H2Teesside Project

Planning Inspectorate Reference: EN070009

The H2Teesside Order

Document Reference 7.1: Change Notification

Notification of Proposed Changes
Detailed
Key Plan

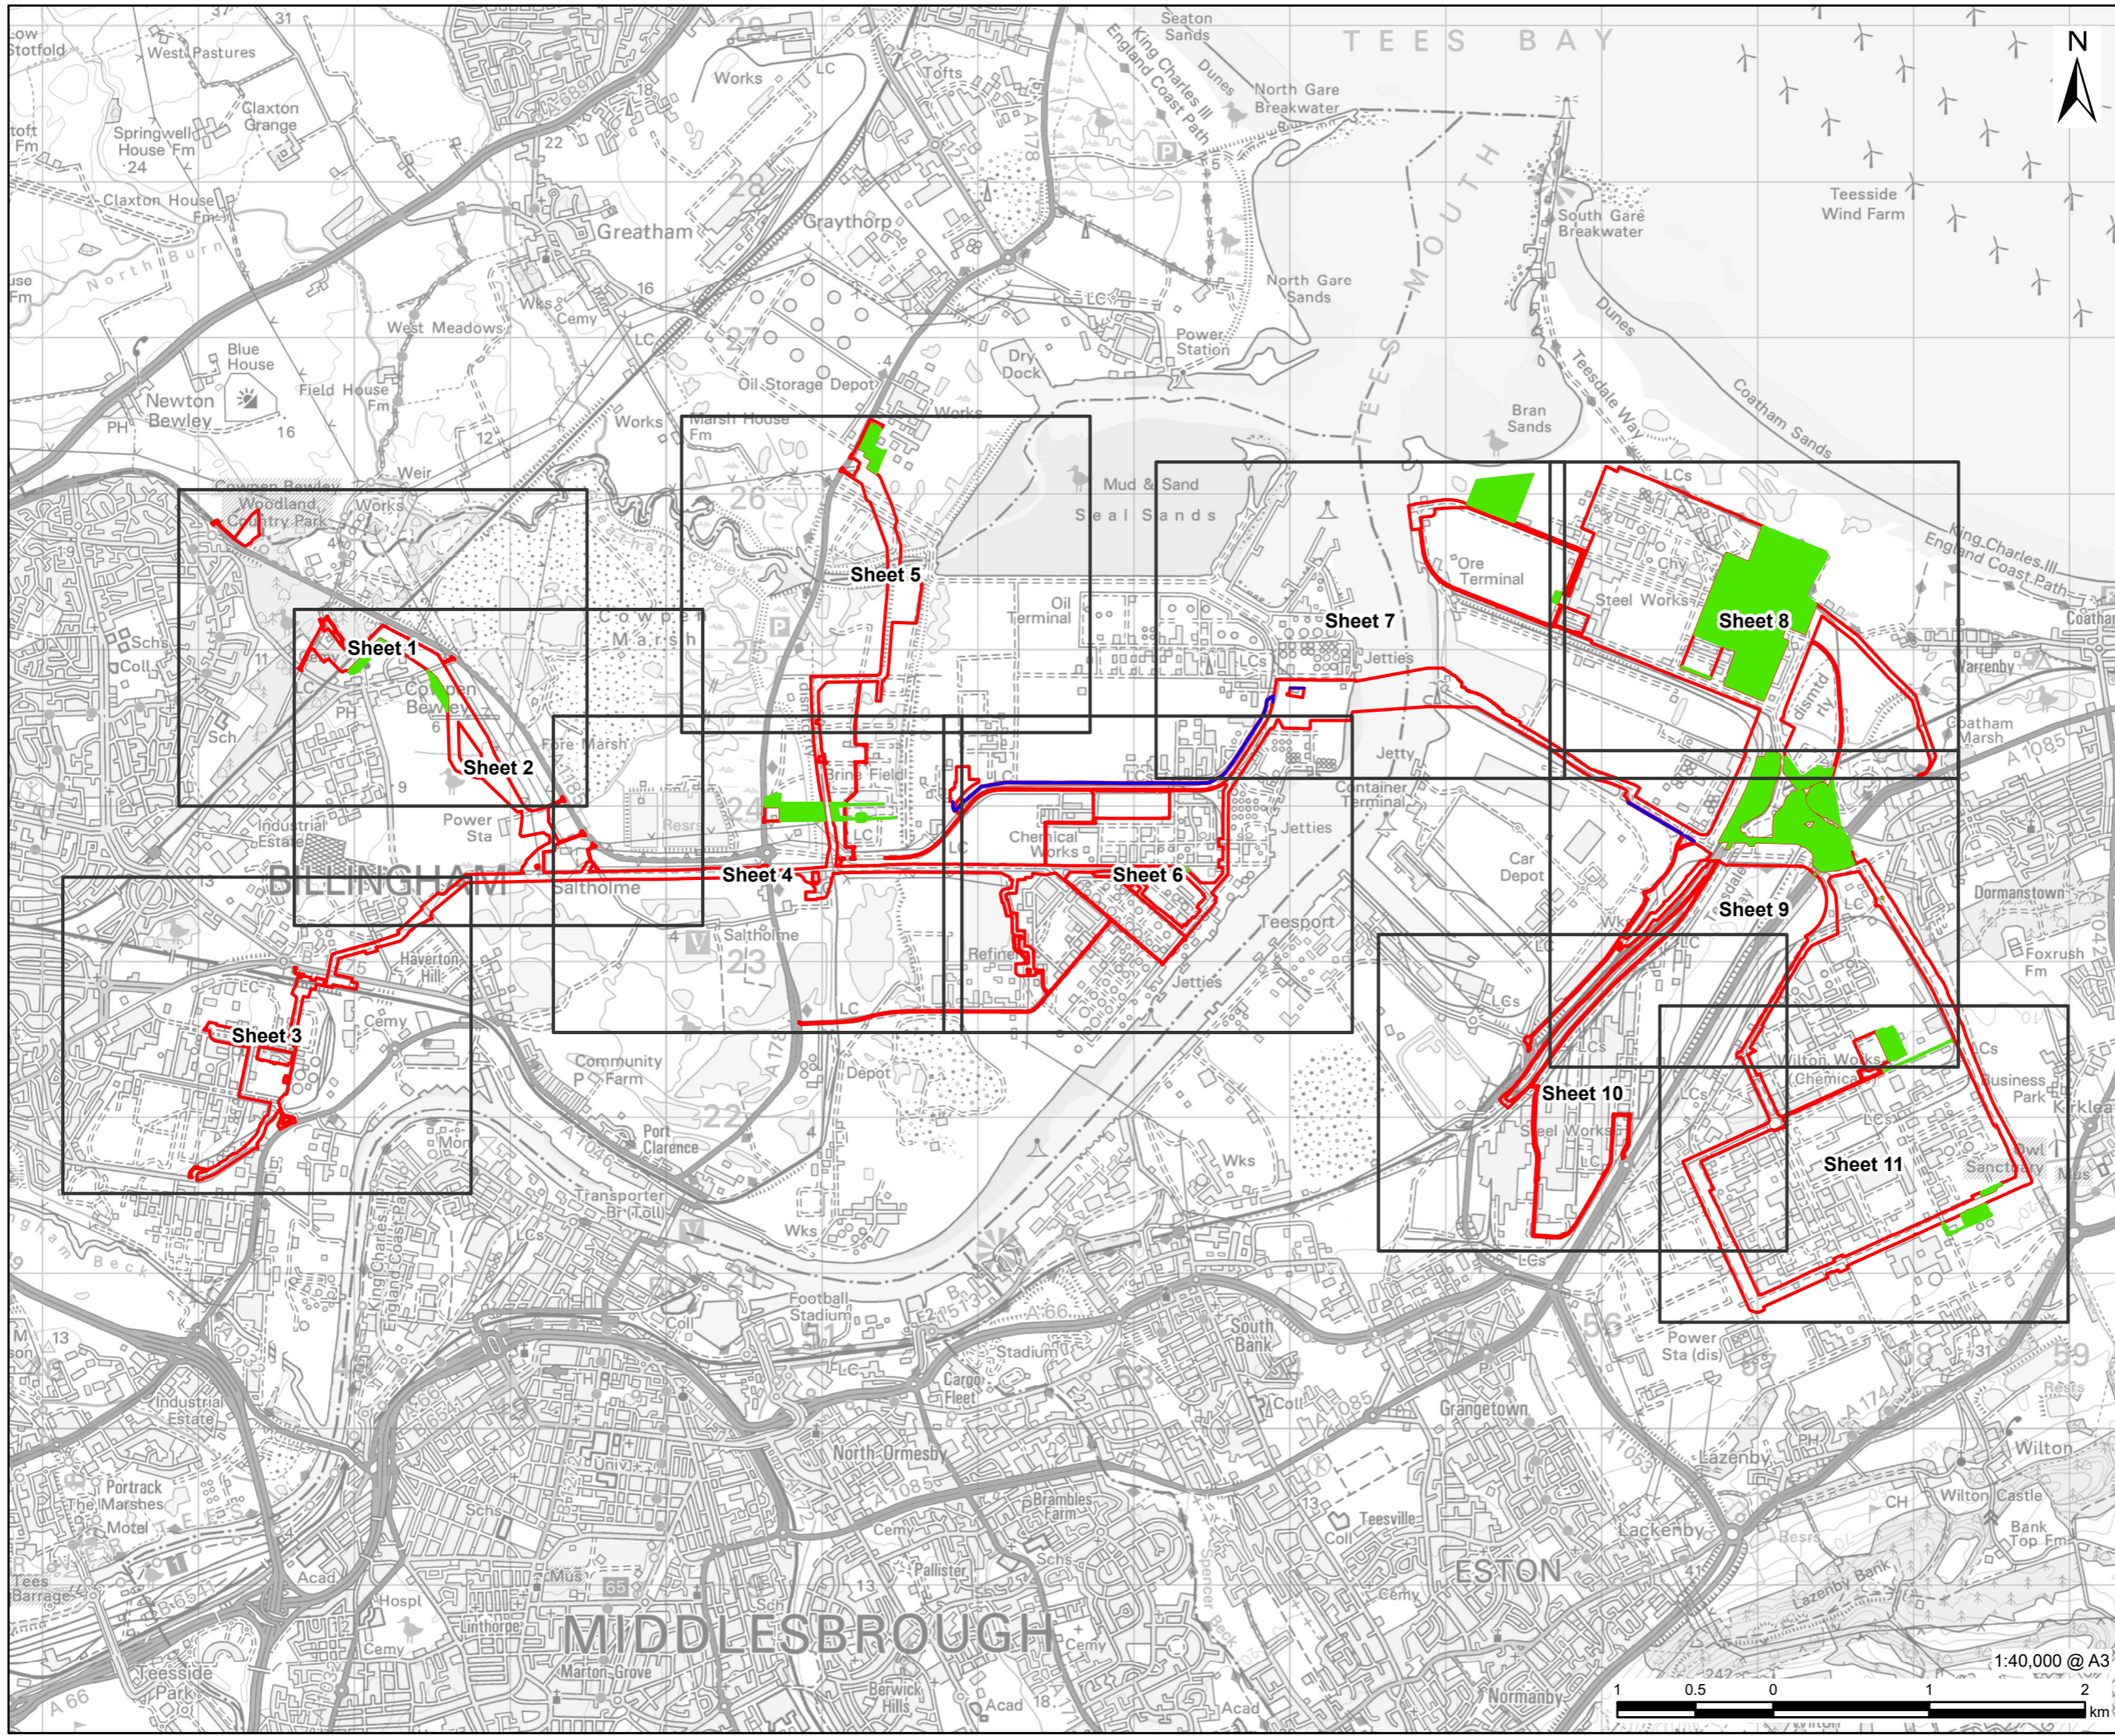
- 2.2.1 The Applicant is proposing 14 changes to the Proposed Development as presented within the DCO Application submitted in March 2024. A brief description of each of the proposed changes and the Work Number (‘No.’) to which they relate within Schedule 1 ‘Authorised Development’ of the draft DCO [APP-027], where relevant, is set out in **Table 2.1** below. The changes are shown on the plans at **Appendix 1**.

- 2.3.9 The proposed changes are explained in more detail below, including the rationale and justification for each change. The location and extent of the proposed changes and the corresponding updates to the Order Limits are shown on the plans at **Appendix 1**. These show the land being removed from the Order Limits (as per the DCO Application submitted in March 2024) shaded in green, additional land that it is proposed to include in the Order Limits (Change 8) shaded in blue and the proposed extent of Order Limits outlined in red. The plans comprise a Key Plan and Sheets 1 to 11 showing the changes in more detail.
